**BEFORE THE HEARINGS PANEL
FOR THE PROPOSED QUEENSTOWN LAKES DISTRICT PLAN**

**STATEMENT OF EVIDENCE OF BRIDGET MARY GILBERT
ON BEHALF OF QUEENSTOWN LAKES DISTRICT COUNCIL**

LANDSCAPE ARCHITECTURE – RURAL VISITOR ZONE – REZONING

18 March 2020

Figure 4: Lake Hawea Holiday Park RVZ rezoning submission area shown in orange outline.

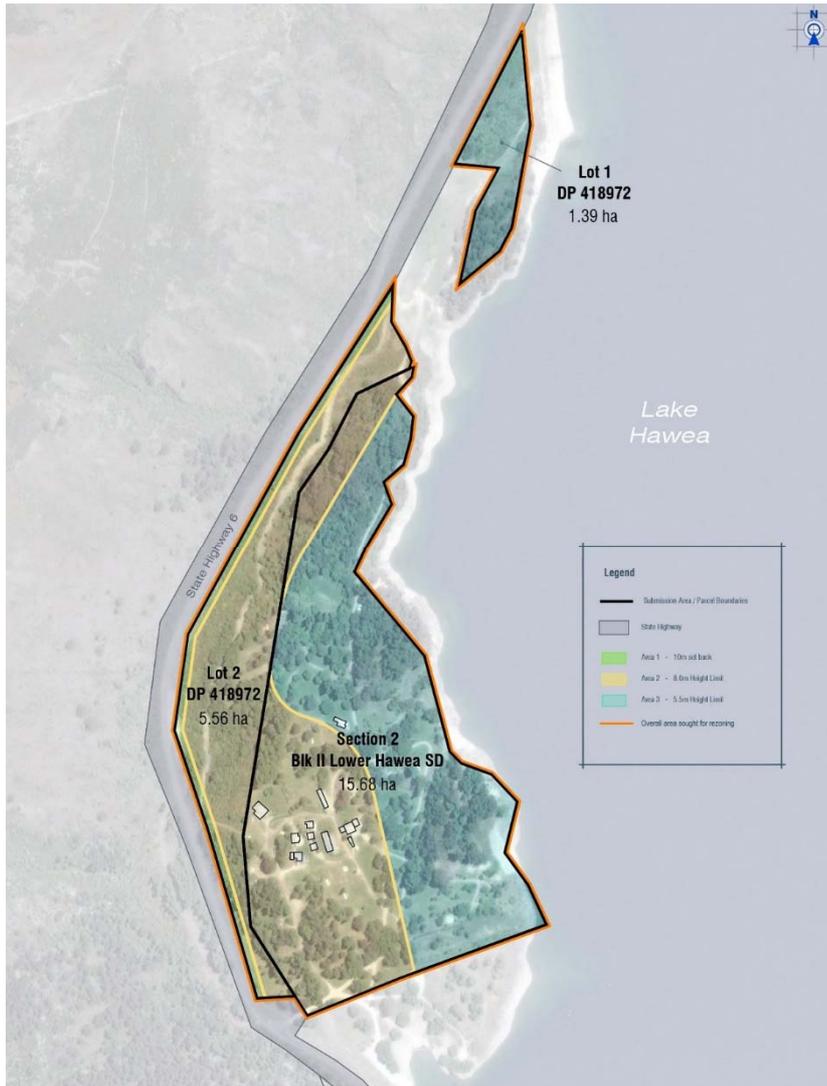
7.10 In light of the notified RVZ provisions, it is my opinion that the landscape sensitivity of the submission site rates towards the mid to higher end of the spectrum as a consequence of its visibility from Lake Hāwea, the lake edge, walking tracks and the state highway (at least in part) and the potential for RVZ development here to undermine the existing township edge.

7.11 As the submission currently 'stands', I do not support the RVZ rezoning relief sought by the Lake Hāwea Holiday Park from a landscape perspective. My reasoning for this stems from the potential for adverse landscape effects identified in the Potential Landscape Constraints listed at paragraph 7.17 below.

Close-range views from SH6 of two-storey and potentially quite intensive and/or inappropriately designed built development (assuming the 10m setback, no building coverage limit and no external appearance controls apply) that may detract from landscape values (naturalness and aesthetic values).

Mid and longer-range views from the lake, lake edge, township, Gladstone and walking tracks in the area to potentially quite intensive and/or inappropriately designed built development (assuming the 10m setback, no building coverage limit and no external appearance controls apply) that may detract from landscape values (naturalness and aesthetic values).

Loss of the perception of the area as a very low-key green node of development as a consequence of potentially quite intensive and/or inappropriately designed built development (assuming the 10m setback, no building coverage limit and no external appearance controls apply). This change in landscape character has the potential to undermine the integrity of a defensible urban edge around the western side of the Hāwea township and contribute the perception of development creep northwards along the western side of the lake that may detract from landscape values (naturalness, aesthetic values and shared and recognised values).

- 7.18** In light of these identified landscape opportunities and constraints, I consider that a proposed RVZ at the Lake Hāwea Holiday Park is likely to be appropriate if additional landscape assessment is provided to support the submission, and dependent on the outcome of that analysis, and also assuming:

- (a) A restricted discretionary or discretionary regime for buildings that would allow the Council to carefully control the number and location of buildings (and associated infrastructure etc.) is imposed to ensure an appropriate landscape outcome.

- (b) A location-specific, structure plan approach is adopted. This may take the form of identifying BRAs, building platforms, accessways (including public routes), vegetation features to be retained and managed and/or protected, and landscape restoration/framework planting areas in addition to location specific development controls in relation to the external appearance of buildings.

- 7.20** In my opinion, the following detailed landscape analysis is required to justify a proposed RVZ in this location. I consider that this information will also be helpful in guiding the most appropriate 'mechanism' for applying the RVZ at the Lake Hāwea Holiday Park:

- (a) Scaled aerial photographs with detailed contour mapping of the submission site and its immediate context.
 - (b) ZTV analysis for the submission site, assuming the proposed building height controls apply (and assuming no vegetation cover), that clearly illustrates the extent of visibility from SH6, the lake and lake edge, Hāwea township, Gladstone, and the walking tracks in the vicinity.
